# 8th Edition (2023) Florida Building Code

Proposed Code Modifications

## STRUCTURAL

# TAC: Structural

Delete Figure R301.2(7) and replace with the following:

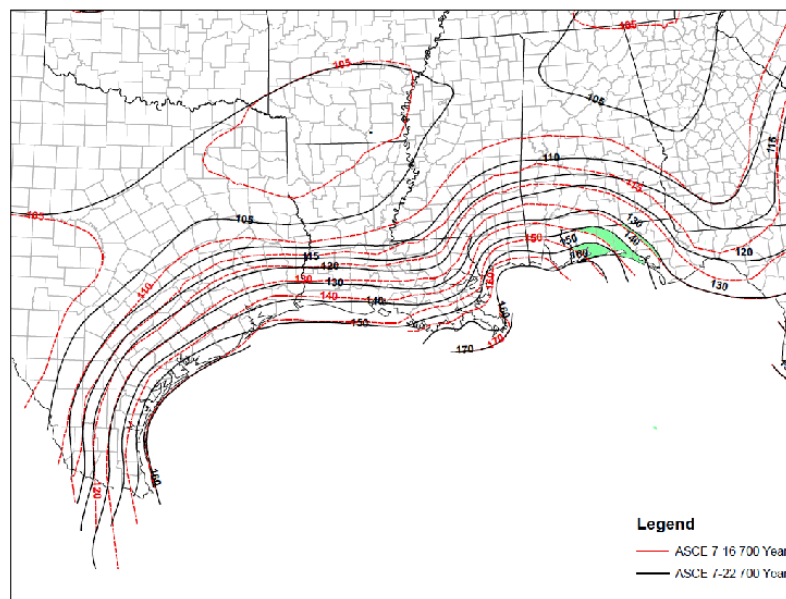
S9971-A1	<b>Proponent</b>	T Stafford	<b>Submitted</b>	8/8/2022 12:29:37 PM	<b>Attachments</b>	Yes
	<b>Rationale:</b> This alternate language comment simply replaces Table R301.2(2) with a revised version. A small error was discovered in the equation for roof slopes ~ 7 degrees for effective wind areas of 20 and 50 square feet. This revised table corrects that error and also adds the design pressures Zone 1&#39; for roof slopes less than 7 degrees. In the original modification, the user was directed to use Zone 1 pressures in Zone 1&#39; or determine Zone 1&#39; from ASCE 7.

Replace Table R301.2(2) in the original modification with the following table:

**FIGURE 704.2.1 TYPICAL SINGLE-SPAN VINYL OR ALUMINUM SOFFIT PANEL SUPPORT**

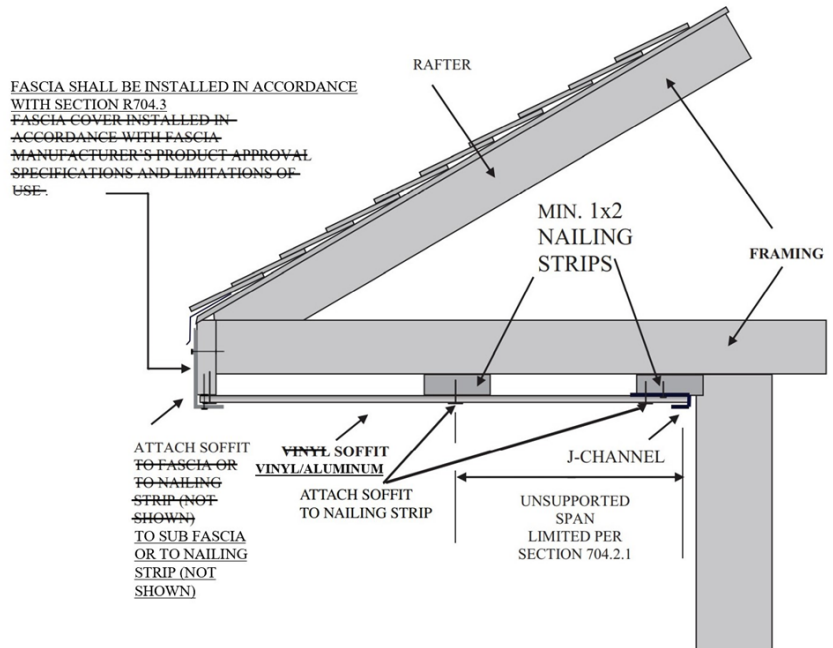
**R704.2.1 Vinyl soffit panels.** Vinyl soffit panels shall be installed using fasteners specified by the manufacturer and shall be fastened at both ends to a supporting component such as a nailing strip, fascia or sub fascia component in accordance with Figure R704.2.1. Where the unsupported span of soffit panels is greater than 12 inches, intermediate nailing strips shall be provided in accordance with Figure R704.2.2 unless a larger span is permitted in accordance with the manufacturer's product approval specification. Vinyl soffit panels shall be installed in accordance with the manufacturer's product approval specification and limitations of use. Fascia covers shall be installed in accordance with the manufacturer's product approval specification and limitations of use and Section R704.3.

FIGURE 704.2.1 TYPICAL SINGLE-SPAN VINYL OR ALUMINUM SOFFIT PANEL SUPPORT

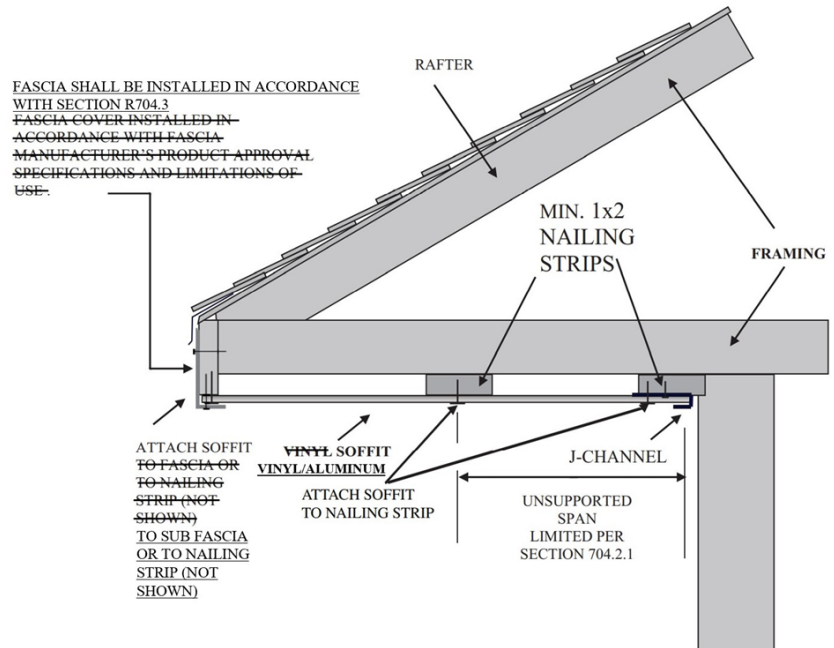
**R704.2.1 Vinyl soffit panels.** Vinyl soffit panels shall be installed using fasteners specified by the manufacturer and shall be fastened at both ends to a supporting component such as a nailing strip, fascia or sub fascia component in accordance with Figure R704.2.1. Where the unsupported span of soffit panels is greater than 12 inches, intermediate nailing strips shall be provided in accordance with Figure R704.2.2 unless a larger span is permitted in accordance with the manufacturer's product approval specification. Vinyl soffit panels shall be installed in accordance with the manufacturer's product approval specification and limitations of use. Fascia covers shall be installed in accordance with the manufacturer's product approval specification and limitations of use and Section R704.3.

FIGURE R704.2.1(1) TYPICAL SINGLE-SPAN VINYL SOFFIT PANEL SUPPORT

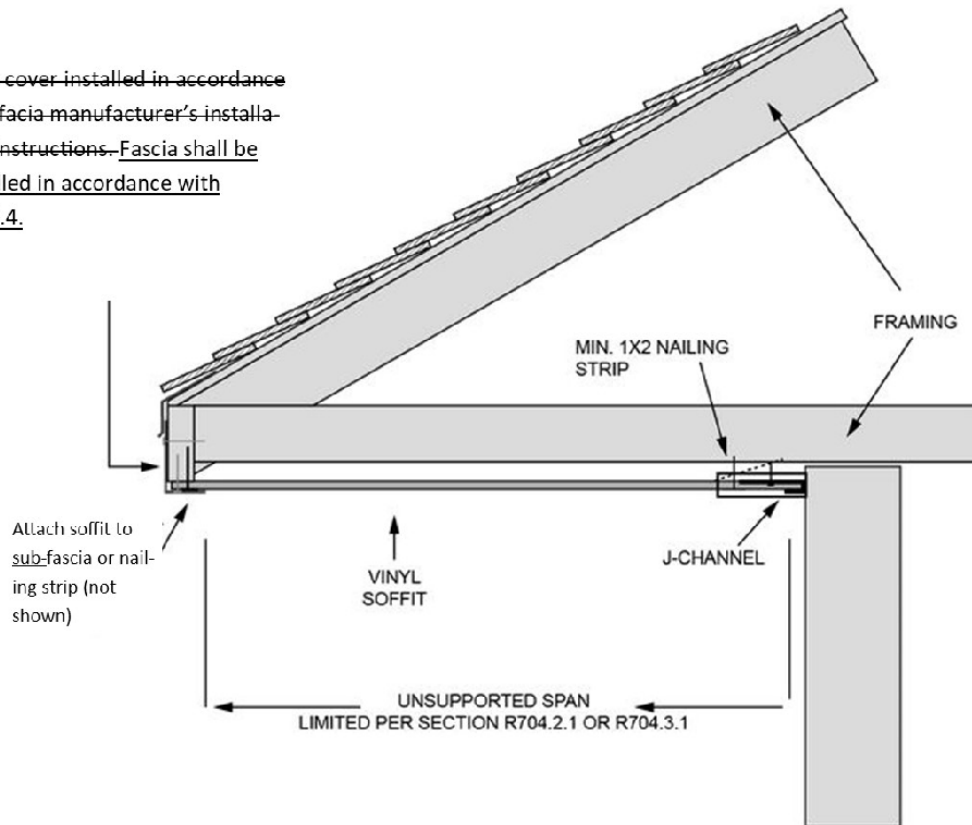
IRC: SECTION R703, SECTION R704, FIGURE R704.2.1(1), FIGURE R704.2.1(2), R704.3.1, R704.4 (New)

FIGURE R704.2.1(2)  
TYPICAL DOUBLE-SPAN VINYL SOFFIT PANEL SUPPORT

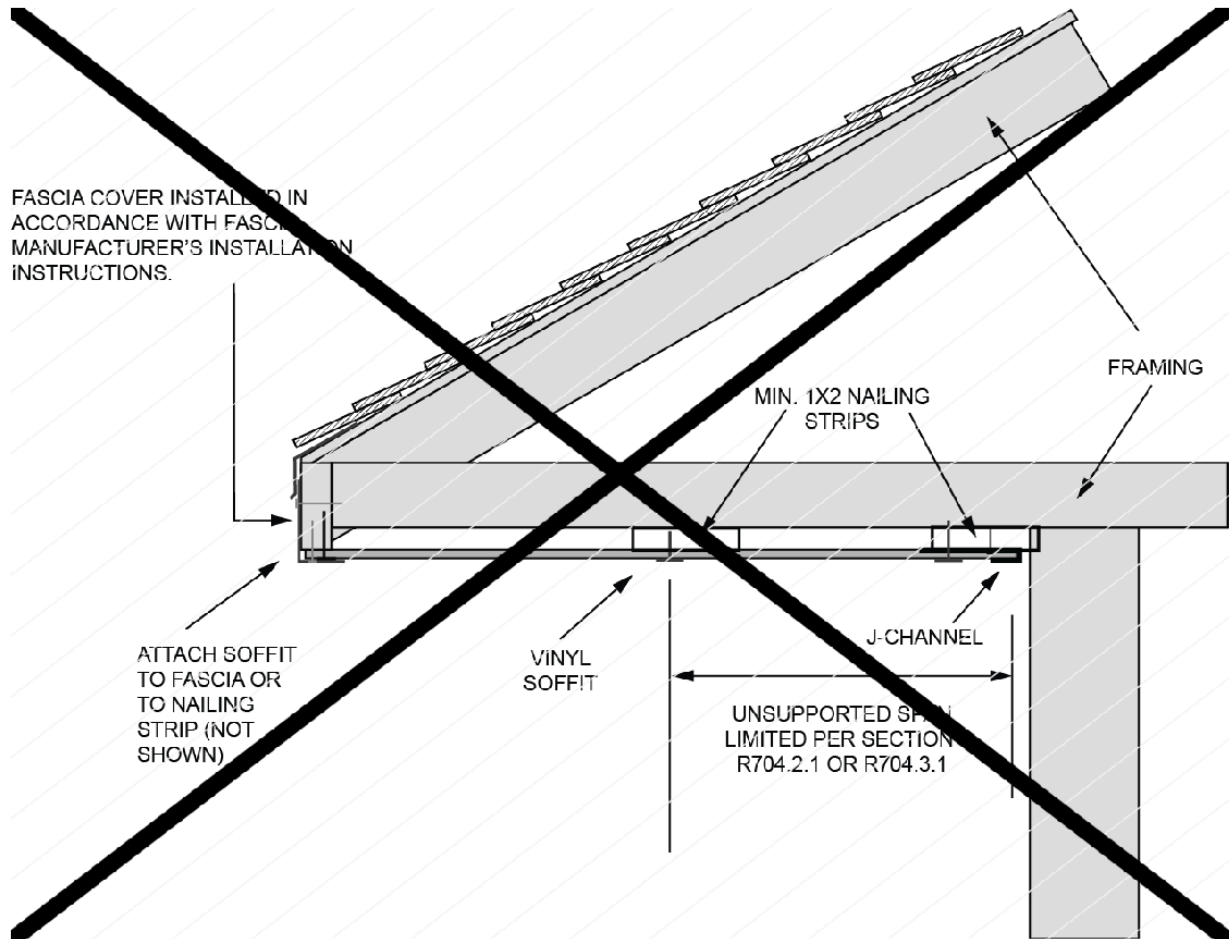
**R704.3.1 Vinyl soffit panels.** Vinyl soffit panels and their attachments shall be capable of resisting wind loads specified in Table R301.2.1(1) for walls using an effective wind area of 10 square feet (0.929 m<sup>2</sup>) and adjusted for height and exposure in accordance with Table R301.2.1(2). Vinyl soffit panels shall be installed using fasteners specified by the manufacturer and shall be fastened at both ends to a supporting component such as a nailing strip, fascia or subfascia component in accordance with Figure R704.2.1(1). Where the unsupported span of soffit panels is greater than 12 inches (305 mm), intermediate nailing strips shall be provided in accordance with Figure R704.2.1(2). Vinyl soffit panels shall be installed in accordance with the manufacturer's installation instructions. ~~Fascia covers shall be installed in accordance with the manufacturer's installation instructions.~~

Delete Figures 1609.3(1), 1609.3(2), 1609.3(3), 1609.3(4) and replace with the following:

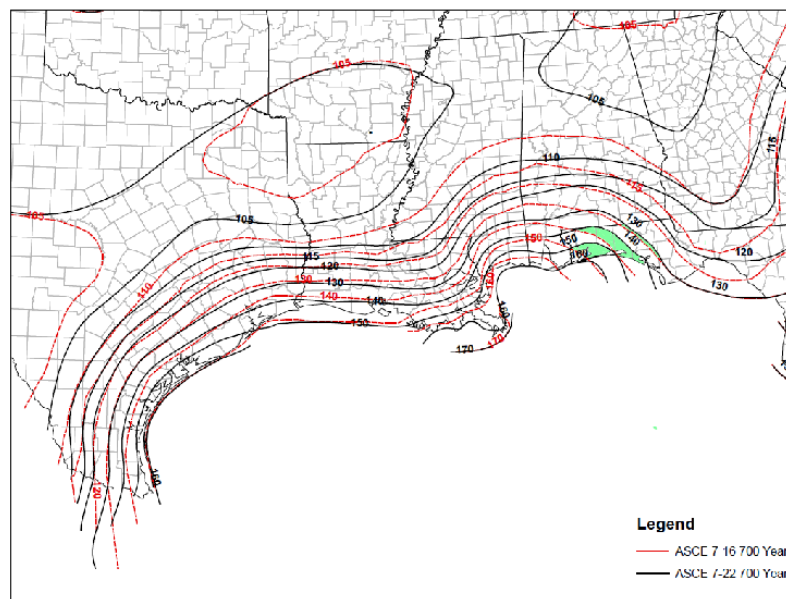
- Slight increases in design wind speeds for the western Panhandle.
- Revised the determination of applicability of the Wind-borne Debris Region in areas where the design wind speed is greater than or equal to 130 mph and less than 140 mph.
- Changes to roof pressure coefficients for mean roof heights less than or equal to 60 ft.
- New provisions for roof pavers
- New provisions for ground-mounted fixed-tilt solar panel systems.
- New provisions for wind loads on elevated buildings (MWFRS and C&C).
- New provisions for tornado loads.

For most of Florida, wind speeds have not changed. However, for the western part of the Panhandle, wind speeds have slightly increased. The following figure shows the impact of these increases for Risk Category II. The 130 mph contour has shifted very slightly northward and eastward. The 140 mph contour and the 150 mph contour have shifted moderately northward and eastward.

Where wind speeds are equal to or greater than 130 mph but less than 140 mph, the Wind-borne Debris region now applies within one mile of the mean high water line where an Exposure D condition exists upwind of the water line. The term “coastal” has been deleted. This change provides a more consistent method for determining the Wind-borne Debris Region in these areas.

**FIGURE 1410.3(1).**

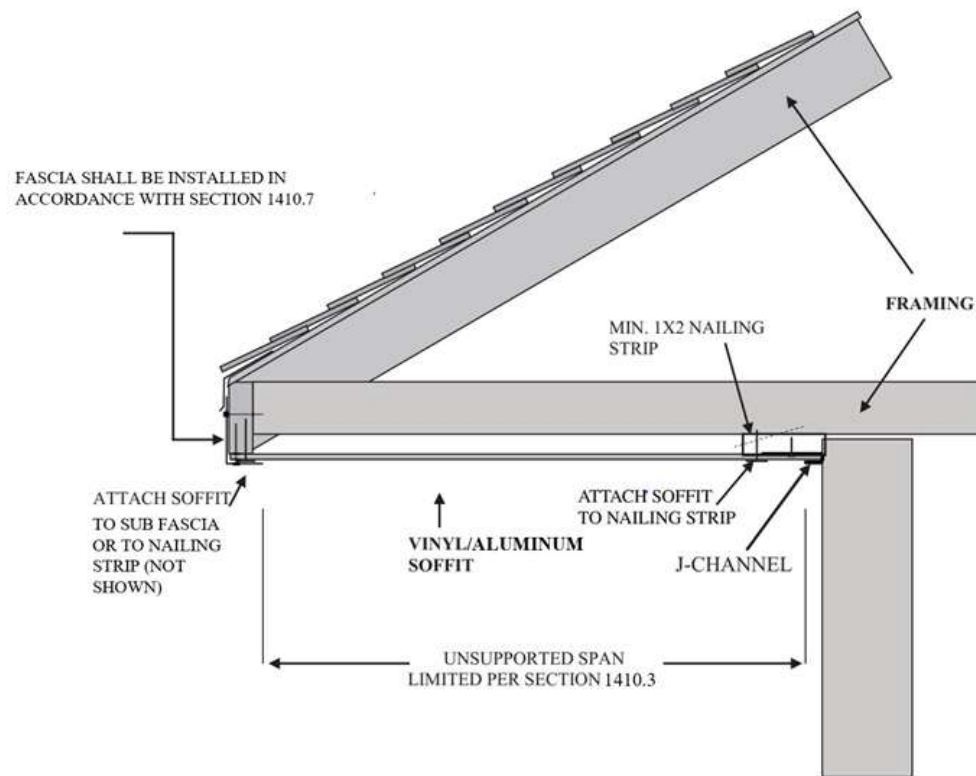
manufacturer's product approval specification and limitations of use. Vinyl and aluminum soffit panels shall be installed in accordance with the manufacturer's product approval specification and limitations of use. Fasteners shall be corrosion resistant. Fascias shall comply with Section 1410.7 and the manufacturer's product approval specification and limitations of use.
